12 March 2021

**Re: DEVELOPMENT APPLICATION NO. DA220/2020 – 18 RANDWICK CLOSE, CASULA
APPLICANT'S RESPONSES AND AMENDED DEVELOPMENT APPLICATION
ADDENDUM STATEMENT OF ENVIRONMENTAL EFFECTS**

Figure 6: Amended DA architectural layout Building B Ground Floor Level

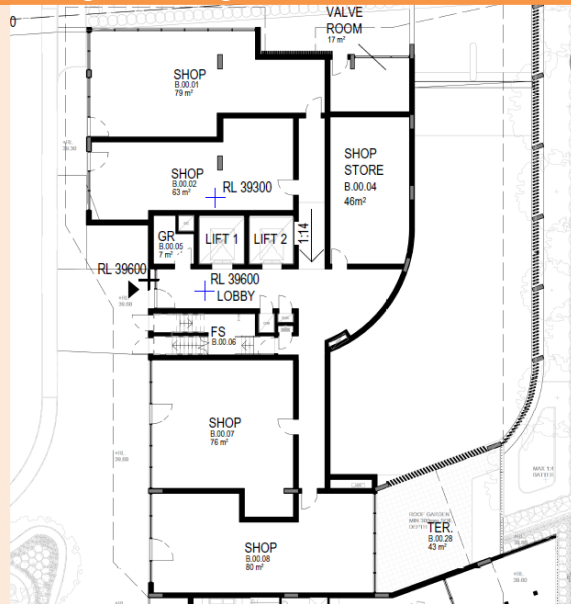
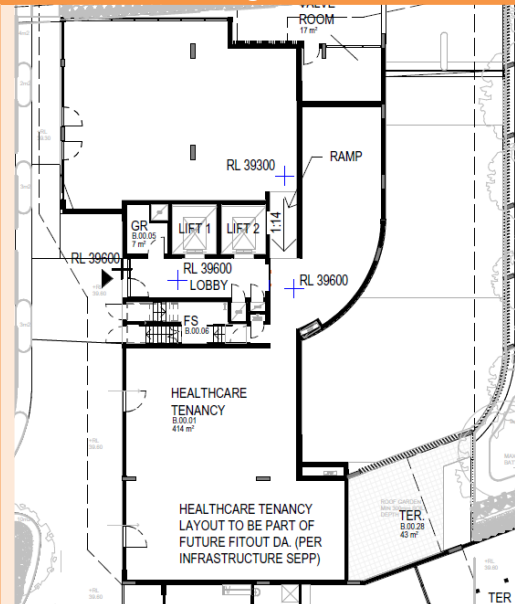
5. Design change to Building B ground floor level with the removal of all the “neighbourhood shops”, and consolidation of the spaces to create a single tenancy capable of supporting usage as a “health services facility” under Clause 57 of *State Environmental Planning Policy (Infrastructure) 2007* (Infrastructure SEPP) - noting that this application seeks approval for the the ground floor area usage as a “health services facility” but does not seek approval for fit out, as the specific tenant is unknown at this time and can be subject to separate approval by the operator of the “health services facility” usage tenant;

Figure 8: Amended DA width of the lift lobby / foyer in Building C is now proposed to be widened to 5.5m wide

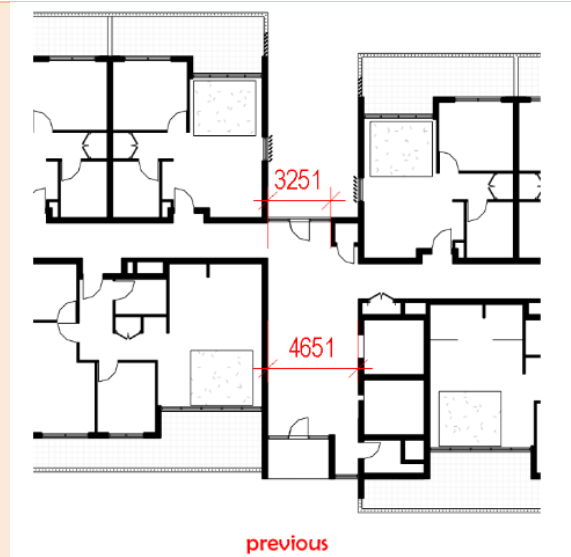
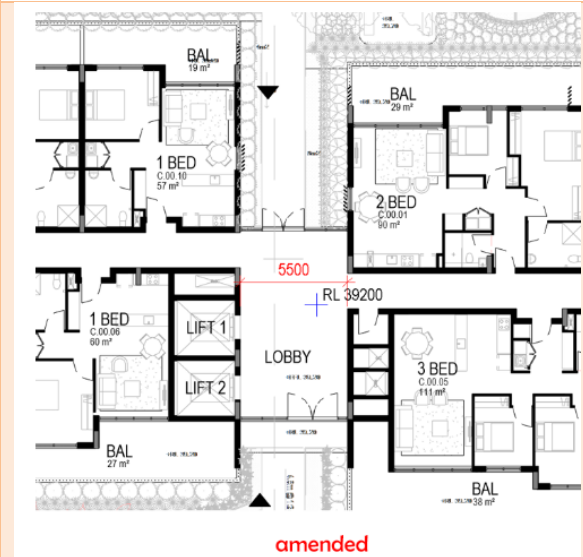
7. In reorientating Building C, it was possible to width of the central lobby area between the east and western sections at each level;
8. The inclusion of a modified entrance to the site from the Randwick Close frontage, with a widened pathway and integrated accessibility ramp;

Figure 10: Amended DA Basement location of the lift core of Building C has been shifted west to accommodate the widening of the lift lobby and “flipping” the building

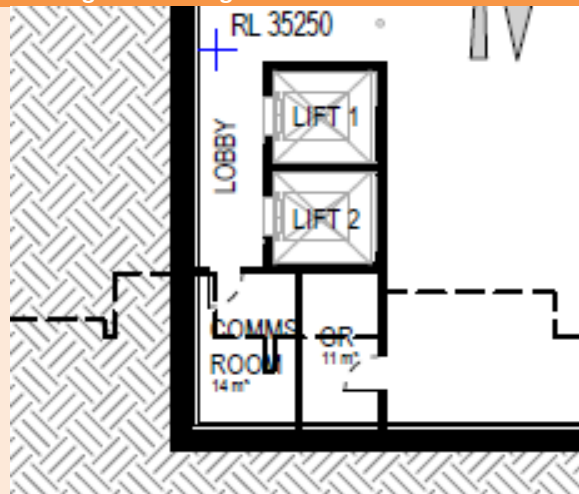
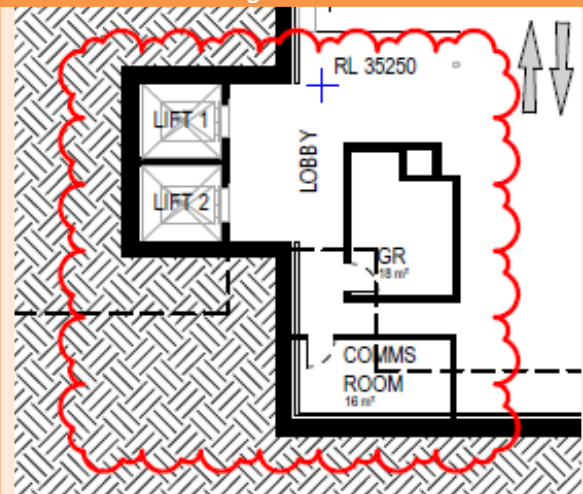
While Building C has involved “reorientating the building by flipping over the building to move the proposed lift core from the eastern side of the lobby to the western side of the lobby, the location and orientation of the proposed units are essentially unchanged. The overall length of the building has increased by some 2m due to the lobby increasing in width from 4m to 6m. This is discussed in more detail in **Table 6** below.

Figure 12: Amended DA architectural northern (Kurrajong Road) elevation Building A Level 5

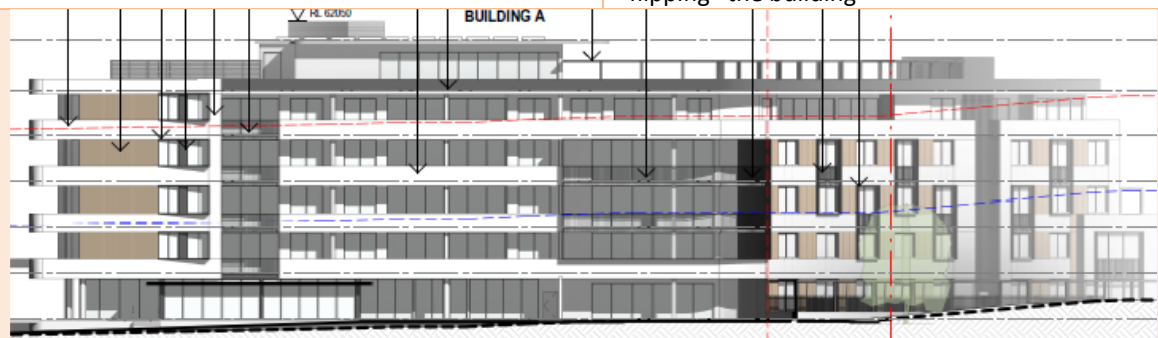
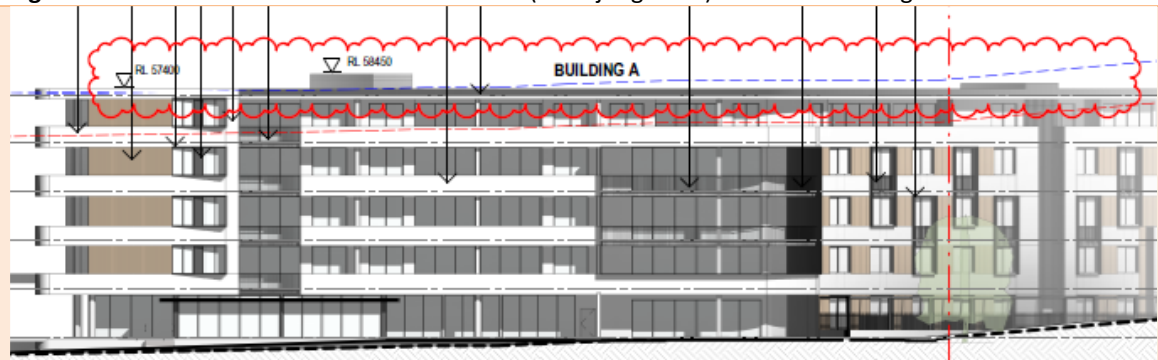
The Amended DA design has removed all of Level 5 floor space which included the communal dining area, amenities, lift lobby, roof terrace and kitchen from Level 5 of Building A. However, Building A still requires lift overrun and access to the roof plant room, condenser deck for maintenance and to the solar cells on the roof of the plant room.

Figure 20: 3D view from Kurrajong Road frontage of Buildings A on right and Building B on left showing portion of buildings which projects through the 15m HOB control Source: Jackson Teece Drawing DA852B

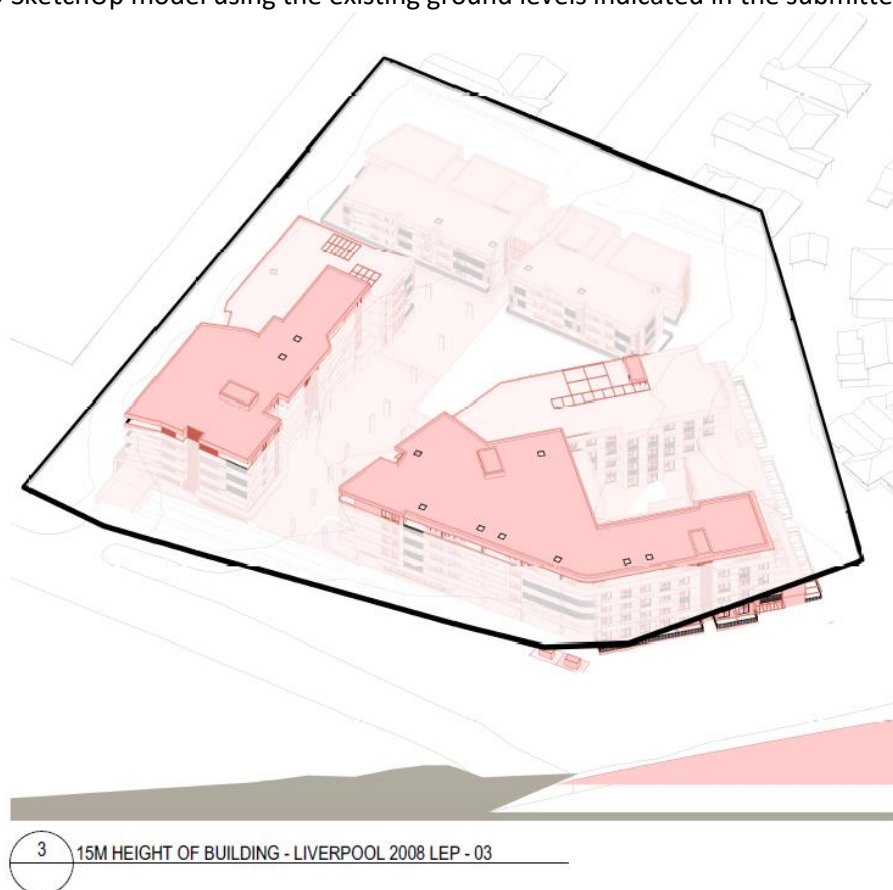
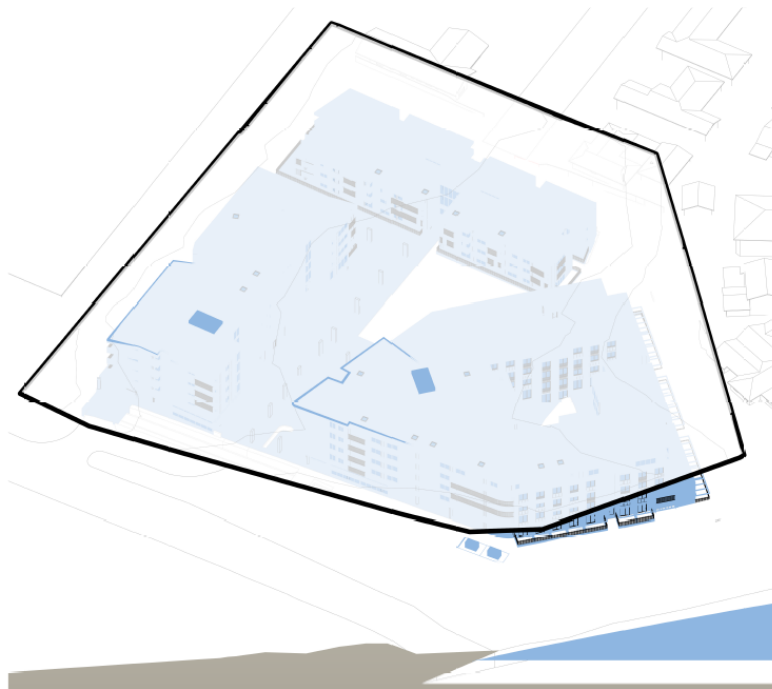
- *The proposal has improved from a built form perspective since the last DEP meeting, however, a building height of 22.050m (i.e. a 6m non-compliance with Council's DCP*

The overall building height of Building A has been reduced by 2150mm to the top of the lift overrun has been calculated as 18.95m, and a minor breach associated with the parapet edge which has been calculated as 18.34m. The majority of Building A is below the 18m requirement of the SCC as shown in **Figures 22 and 23**, and complies with the 15m LLEP control, see **Figures 20 and 21**.

The overall building height of Building B has been reduced by 1750mm to the top of the lift overrun has been calculated as 19.15m. And a minor breach associated with the parapet edge which has been calculated as

Figure 27: Extract DA030B Site Plan – Building A 10m setback.

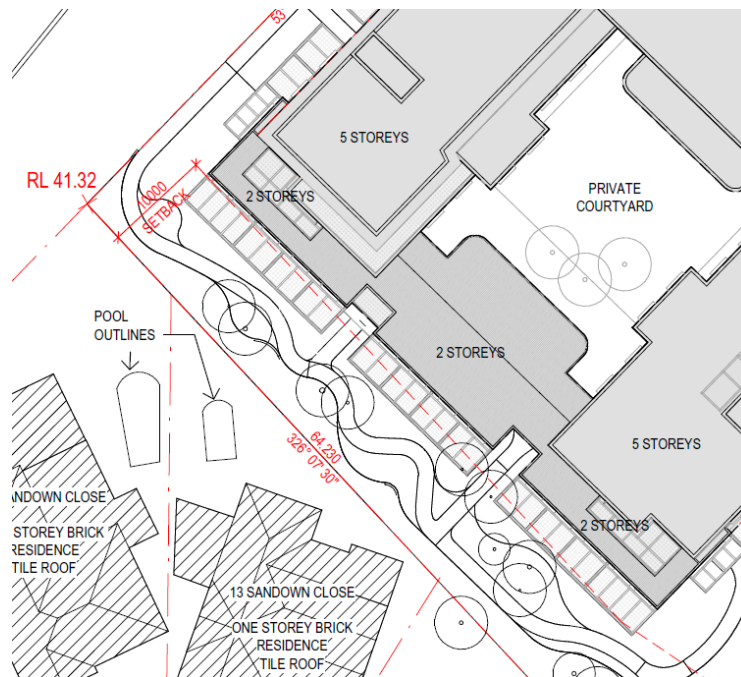
In addition, the Amended DA design includes details of the setback in relation to the south-west boundary as demonstrated in the extract from the Site Plan in amended architectural drawing DA030 B of greater than 10m for the ground floor level and level 1, being the lower 2 storeys of Building A. See extract below:

Figure 28: Extract DA113B Levels 2 & 3 – Building A 13.916m setback.

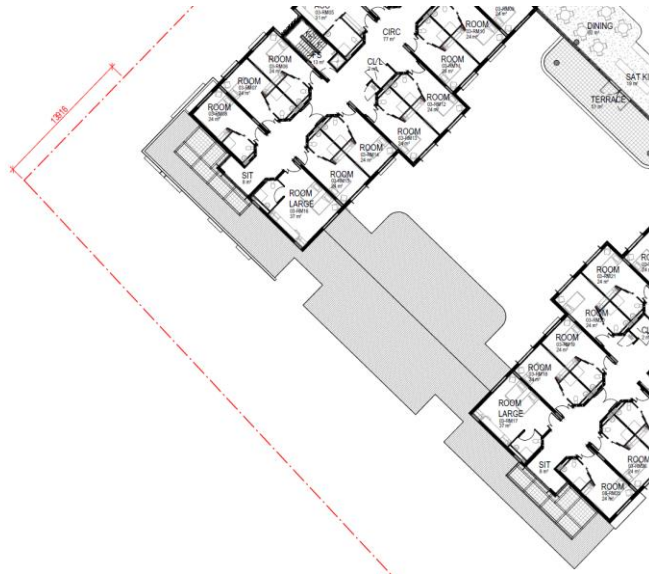
Levels 2 and 3 is stepped back to 13.916m (being just under 4m in addition to the ground and level 1 setback of a minimum of 10m) from the south-west boundary as shown in amended architectural drawing DA 113B Levels 2 & 3 of Building A, see extract below:

Figure 29: Extract DA114B Level 4 – Building A 18.052m setback.

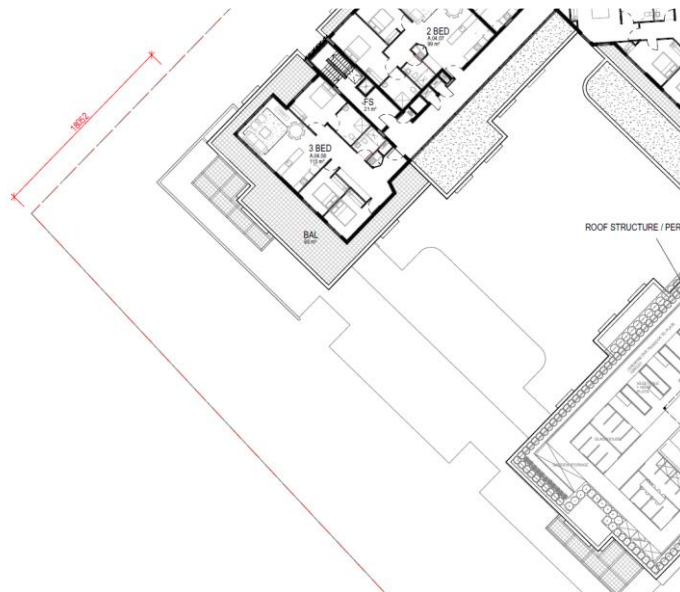
Level 4 is stepped back to 18.052m (being just over 4m in addition to the level 2 and 3 setbacks of a minimum of 13.916m) from the south-west boundary as shown in amended architectural drawing DA 114 B Level 4 of Building A, see extract below:

Figure 33: Extract from page 15 Updated Landscape Architectural report - Arcadia

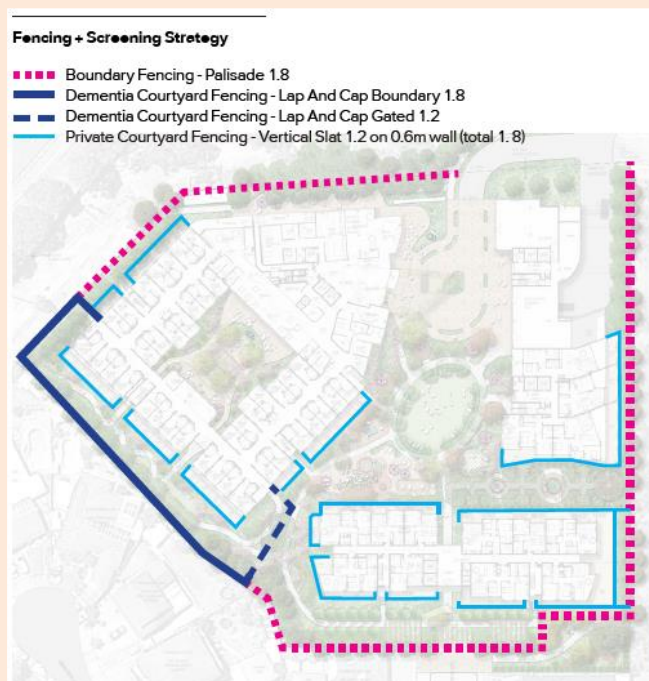
environment, however it needs to be more public and feel more open. Revise the proposal so that it is more inviting and connects better to the adjacent park and to other areas around the site including considering broader neighbourhood connections and movement patterns (e.g. to Casula Mall).

As detailed at page 15 of the Updated Landscape Architectural report access into the site from Kurrajong Road is unrestricted as part of the entrance to the site, and around the perimeter of the site except at the entrance is proposed to have open style fencing. Access to the central communal courtyard is available to the public. Refer to extract in **Figure 33** below:

Figure 34: Extract from page 14 Updated Landscape Architectural report – Arcadia

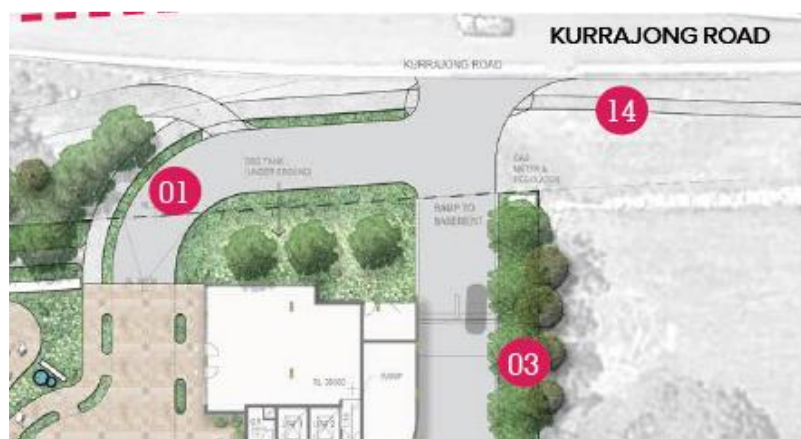
- ***The current proposed entry from Randwick Close is not welcoming: it does not read as a publicly accessible entrance to the site or consider the broader connections to the site (e.g. Connections to Casula Mall). Reinforce or clarify the sense of***

arrival and connection to the site and through the site, for the community that will be approaching from the south. Hard and soft landscape strategies may be employed to achieve this (e.g. lighting, legibility and signage).

Please see extract from page 14 "Landscape Plan Ground Level" in **Figure 34** below:

Figure 8 (repeated): Amended DA width of the lift lobby / foyer in Building C is now proposed to be widened to 5.5m wide.

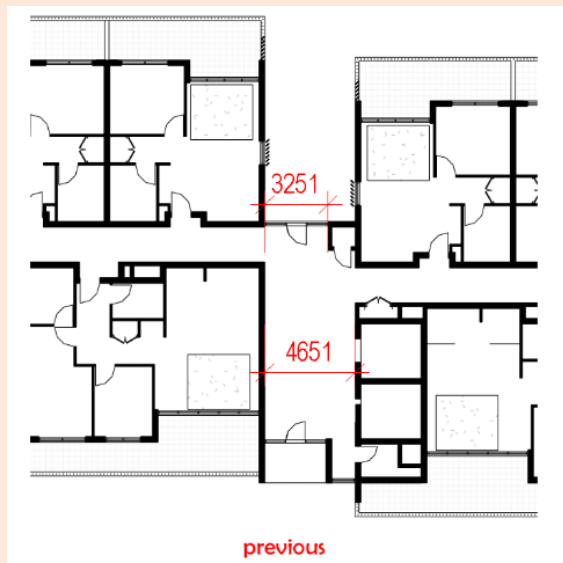
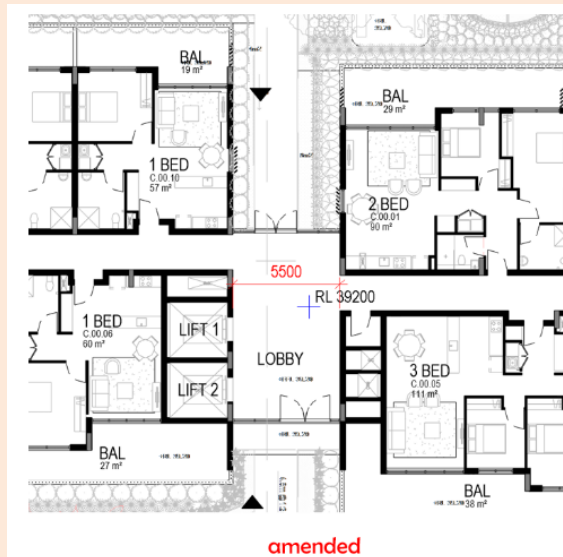
- ***Despite the reference to an open lobby located between the two wings of building C, the lobby does not address Randwick Close, and is effectively a wall rather than a gateway into the site. Revise the proposal to achieve a more direct physical and visual link between the adjacent open space and frontage***

1. the reorientating of Building C by “flipping” the design such that the lift core is now located on the western side of the entry lobby with associated changes into basement level;
2. In reorientating Building C, it was possible to width of the central lobby area between the east and western sections at each level;
3. The inclusion of a modified entrance to the site from the Randwick Close frontage, with a widened pathway and integrated accessibility ramp;
4. The provision of a widened public accessway from Randwick Close to Daruk Park by utilising a portion of the site and retention of existing tree with supplementary landscaping and renewed footpath;
